**METROPOLITAN DEVELOPMENT COMMISSION
REGIONAL CENTER HEARING EXAMINER**

STAFF REPORTS FOR JANUARY 28, 2016

Case Number	2015-REG-116 (A and B)
Address (approx.)	1802 North Illinois Street
Location	Center Township, Councilmanic District # 15
Petitioner	Neighborhood Downtown Zoning Assistance, Inc., by David Kingen and Justin Kingen
Zoning	HD-1 (RC)
Request	Regional Center Approval to provide for: <ul style="list-style-type: none"> a. Demolition of a one-story building, and b. Expansion of a surface parking lot

Case Number	2015-REG-151
Address (approx.)	350 West St. Clair Street
Location	Center Township, Councilmanic District # 15
Petitioner	Chase Sorrick, by Andrew Buroker
Zoning	CBD-2 (RC)
Request	Regional Center Approval to provide for updated elevations, floor plans and site plans, for a multi-use development, including student housing, with 194 units, and commercial retail, along the Central Canal.

Site plan of proposed surface parking lot expansion (top) and optional landscaped area in place of parking lot expansion – 2015-REG-116B

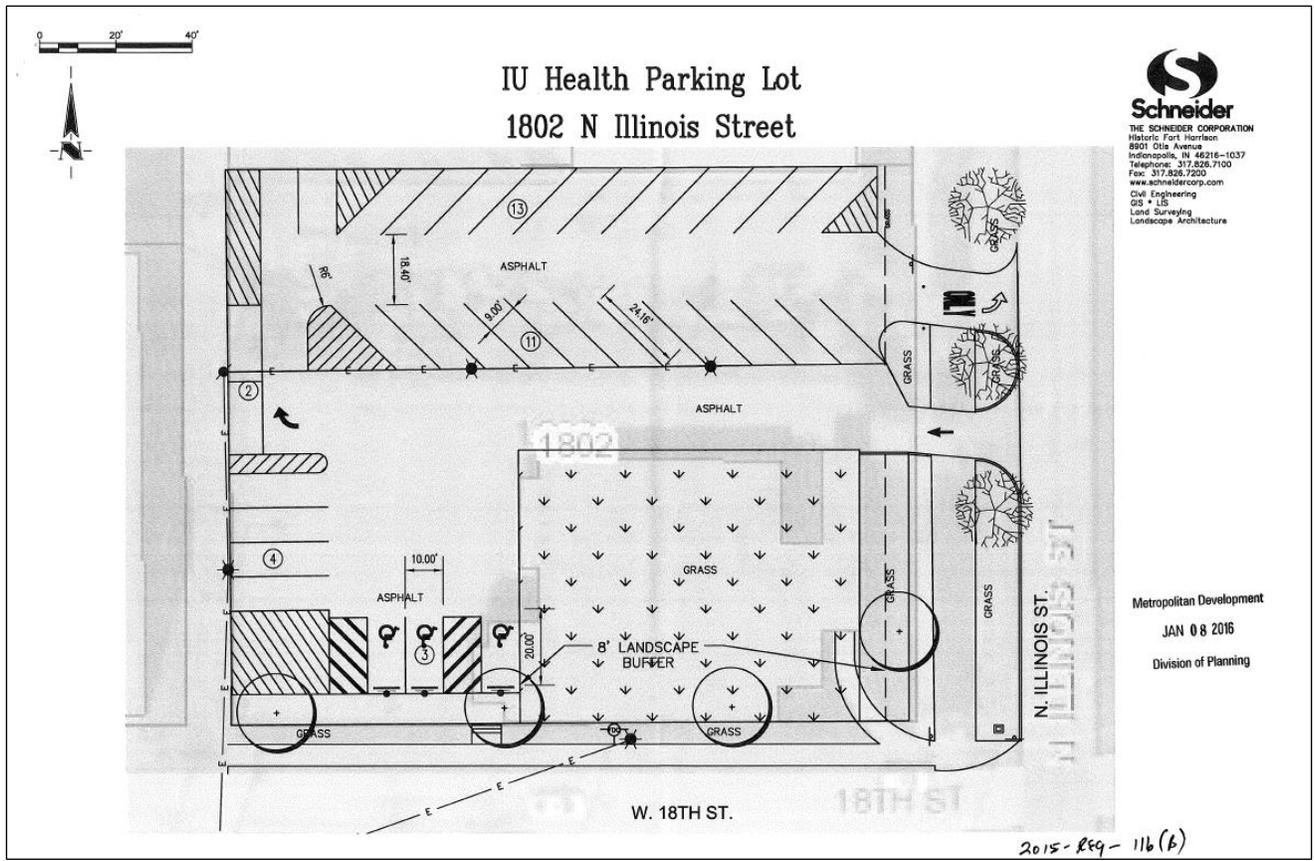
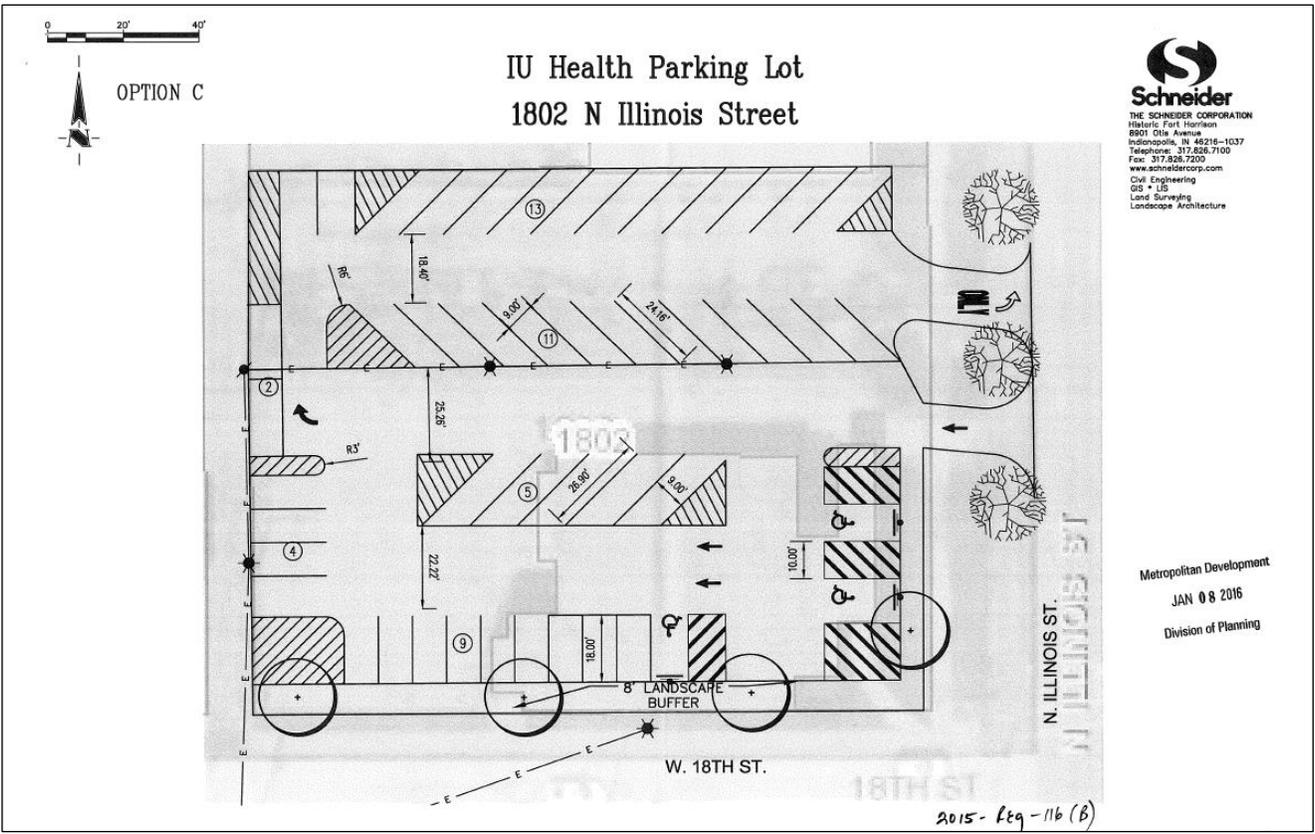
2. Part B of the request would provide for an expansion of the surface parking lot. Guidelines SC 1.2.1, SC 3.1.1 and SC 3.2.1 relate to discouraging surface parking lots. The proposed expansion of an existing parking lot is relatively minor and would not affect the implementation of the Guidelines in a substantial manner.

4. A landscape plan was not submitted to the file. Guidelines US 1.3.2, CA 4.4.3, CA 4.6.1, CA 4.6.2, CA 4.6.4, CA 4.6.6 and CA 4.6.7 should be reviewed and a landscape plan submitted and subject to planning staff review and approval, prior to the hearing.

5. A lighting plan was not submitted to the file to identify the location of lighting standards. Additionally, a photometric plan has not been submitted to the file. A photometric plan should detail light standards and photometric levels for the site. Only full cut and shielded light standards are permitted with minimum foot-candle power outlined in CA 4.3.2 and CA 4.3.3. Pedestrian areas must be lighted for safety (CA 4.3.1). Staff requests that all required lighting information be submitted prior to the release of an Improvement Location Permit and subject to review and approval of the Administrator.

Staff **recommends approval** of the Regional Center Approval petition subject to the following condition:

The Summary items four and five must be met.

Site Plan (top) and South elevation – 2015-REG-151

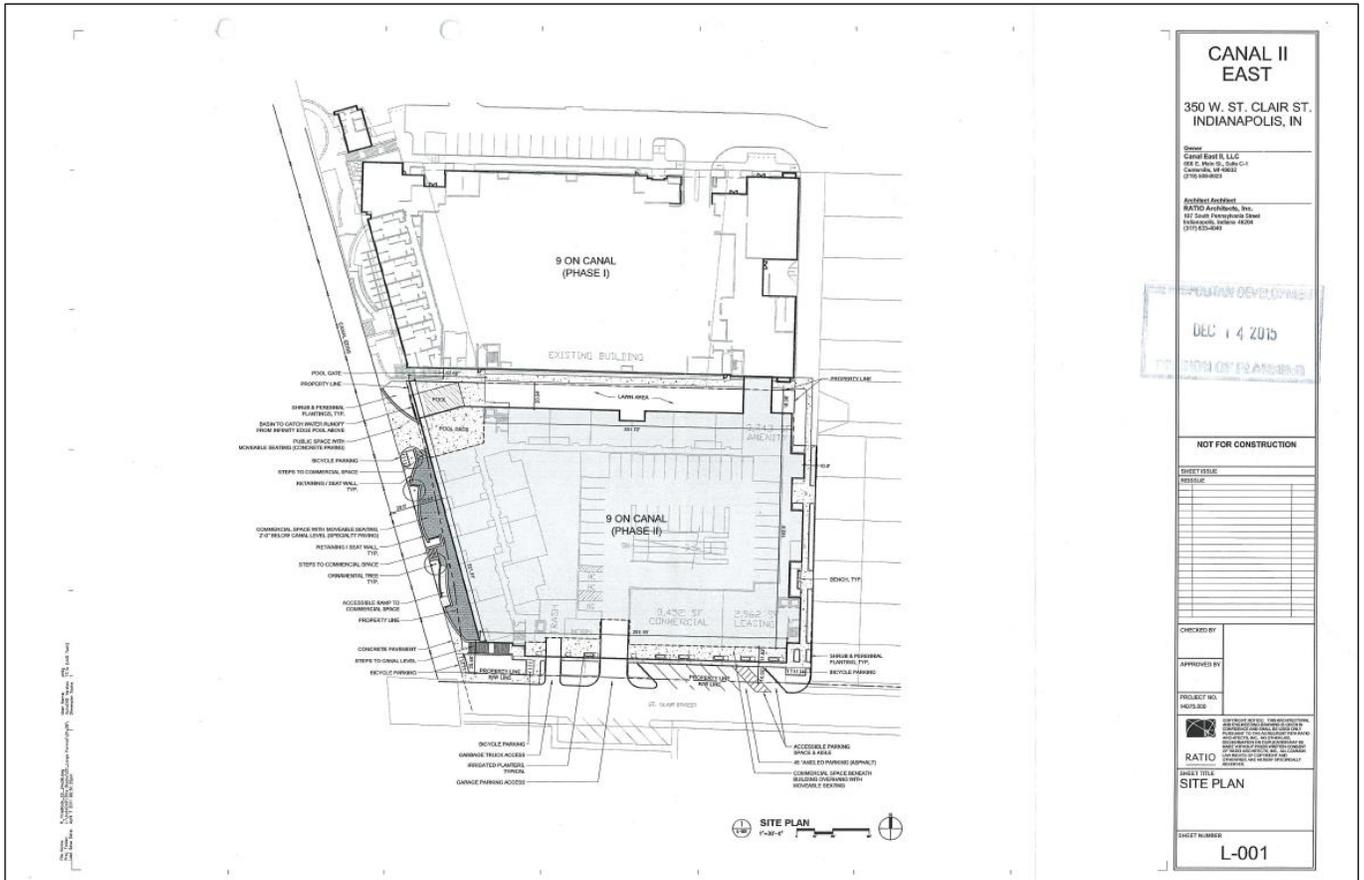
1. Guideline CA 2.1.6 requires that a wall over 30 feet in length, adjacent to a pedestrian way or sidewalk, shall incorporate visual interest. The west elevation indicates that a multi-story brick façade at approximately 36 feet in length would be adjacent to the canal pedestrian way. An amended elevation plan shall be submitted and subject to planning staff review and approval, prior to the hearing.
2. Detailed window information is not available at this stage of development. Staff requests that window information be submitted prior to the release of an

3. A lighting plan was not submitted to the file to identify the location of lighting standards. Additionally, a photometric plan has not been submitted to the file. A photometric plan should detail light standards and photometric levels for the site and at each entrance. Lighting must be provided at each entrance and must be dusk to dawn. Only full cut and shielded light standards are permitted with minimum foot-candle power outlined in CA 4.3.2 and CA 4.3.3. Pedestrian areas and entries must be lighted for safety (CA 3.1.3 and CA 4.3.1). Staff requests that all required lighting information be submitted prior to the release of an Improvement Location Permit and subject to review and approval of the Administrator.

4. A landscape plan was not submitted to the file. Guidelines US 1.3.2, CA 4.6.1, CA 4.6.4, CA 4.6.6 and CA 4.6.7 should be reviewed and a landscape plan submitted and subject to planning staff review and approval, prior to the hearing.

1. The Summary items must be met.
2. Address numerals shall be installed on the building façade (CA 2.5.8), prior to building occupancy.
3. Specific exterior site furnishings for the proposed outdoor café were not submitted. CA 4.1.1, CA 4.1.2, CA 4.1.4 and CA 4.1.5 should be reviewed. Plans shall be submitted and subject to staff approval, prior to occupancy of the building.
4. All additional signage within two years of MDC approval requires planning staff review and approval. After the two-year period, a new Regional Center Approval petition would be required for review and subsequent approval of any proposed signage.
